DART AEROSPACE LTD		Work Order:	34946
Description: Crosstube High-High Fwd		Part Number:	D205-596-101
Inspection Dwg: D205-596-101 Rev: A		Page 1 of 1

# DART SERVICE INSTRUCTION

TO AMEND INSTALLATION INSTRUCTIONS IIN-D205-594 Rev. C (AND EARLIER) AND  
INSTRUCTIONS FOR CONTINUED AIRWORTHINESS ICA-D205-594 Rev. 2 (AND EARLIER)  
REF. CANADIAN STC: SH03-6  
REF. FAA STC: SR01742NY

A	NEW ISSUE	MB	07.11.16
REV.	DESCRIPTION	BY	DATE
DESIGN		<b>DART AEROSPACE LTD</b> HAWKESBURY, ONTARIO, CANADA	
DRAWN			
CHECKED		DRAWING NO.	REV. A
MFG. APPR.		DSI 9396	SHEET 1 OF 2
APPROVED		TITLE	SCALE
DE APPR.		CROSSTUBE SUPPORT CHANGE	NTS
DATE	07.11.16	COPYRIGHT © 2007 BY DART AEROSPACE LTD THIS DOCUMENT IS PRIVATE AND CONFIDENTIAL AND IS SUPPLIED ON THE EXPRESS CONDITION THAT IT IS NOT TO BE USED FOR ANY PURPOSE OR COPIED OR COMMUNICATED TO ANY OTHER PERSON WITHOUT WRITTEN PERMISSION FROM DART AEROSPACE LTD.

**FIGURE 1: INSTALLATION OF SUPPORT ON CROSSTUBE**

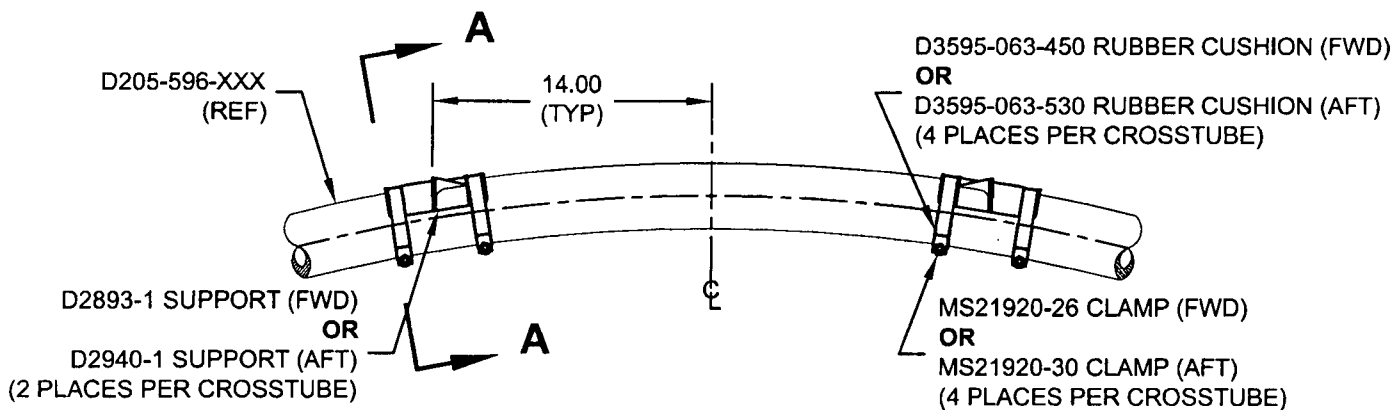
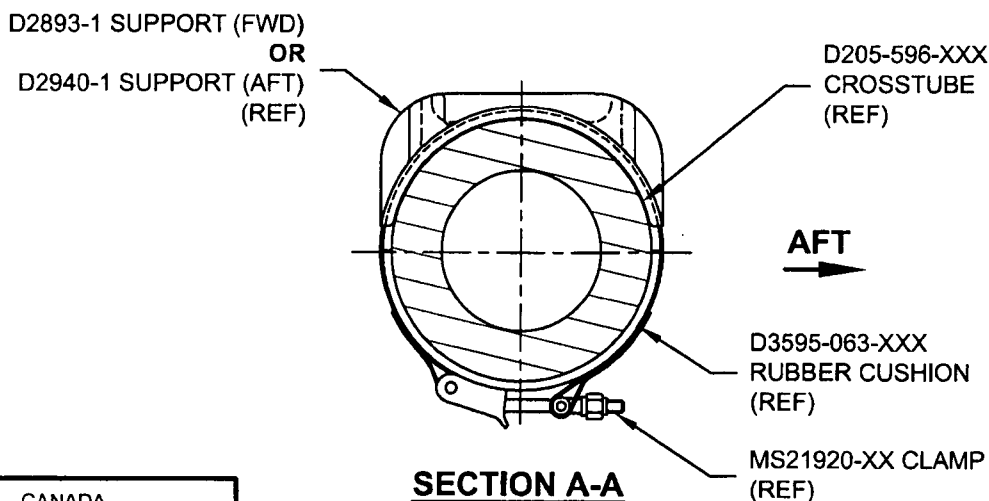
For D205-596-101/-103 Crosstubes (ref. 39" Landing Gear) or D205-596-105/-107 Crosstubes (ref. 31" Landing Gear) at CHG 002 or later, the D2856-600-851/-1009 Abrasion Strips have been removed, the D2893-1 and D2940-1 Supports have been bonded onto the crosstubes using Magnobond 6398 and D3595-063-450/-530 Rubber Cushions have been installed underneath the MS21920-26/-30 Clamps. Amend Parts List of IIN-D205-594 Section 5 and ICA-D205-594 Section 32.8 as follows:

To prevent the supports from shifting on D205-596-101/-103/-105/-107 Crosstubes at CHG 001, the D2893-1 or D2940-1 Supports should be removed and re-installed as follows:

- 1) Follow section 32.1 of ICA-D205-594 for the removal of the crosstubes from the helicopter.
- 2) Remove the MS21920-24/-28 Clamps that fasten the D2893-1 and D2940-1 Supports from the crosstubes per Section 32.3 of ICA-D205-594.

- 3) Remove the D2856-600-851/-1009 Abrasion Strips from the crosstube per section 32.5 of ICA-D205-594.
- 4) Inspect the crosstube surface underneath the supports for corrosion and mechanical damage per items 5.3.1 and 5.3.2 of the 300 hour inspection. Repair damage within acceptable limits and touch up finish per item 5.3.3 of the 300 hour inspection.

- 5) Inspect the supports for corrosion and mechanical damage per items 5.3.4 of the 300 hour inspection. Repair damage within acceptable limits and touch up finish per item 5.3.4 of the 300 hour inspection.

- 6) Abrade area to which support will be applied with 400 grit sandpaper. Saturate a clean cloth with MEK or 4105S Wash'n'Wipe Degreaser or equivalent and wipe area until there is no residue.

- 7) Apply a 0.03" to 0.06" thick layer of Magnobond 6398 underneath D2893-1 or D2940-1 Supports and re-install the Supports on the crosstube as shown in Figure 1. Install a D3595-063-450/-530 Rubber Cushion on each MS21920-26/-30 Clamp. Position and secure the D2893-1 or D2940-1 Supports on the crosstube using MS21920-26/-30 Clamps. Torque clamps to 80-100 in-lb. Let the D205-596-101/-103/-105/-107 Crosstube Assembly cure before re-installing the crosstube on the aircraft.

- 8) Re-install the D205-596-101/-103/-105/-107 crosstube per section 32.2 of ICA-D205-594.
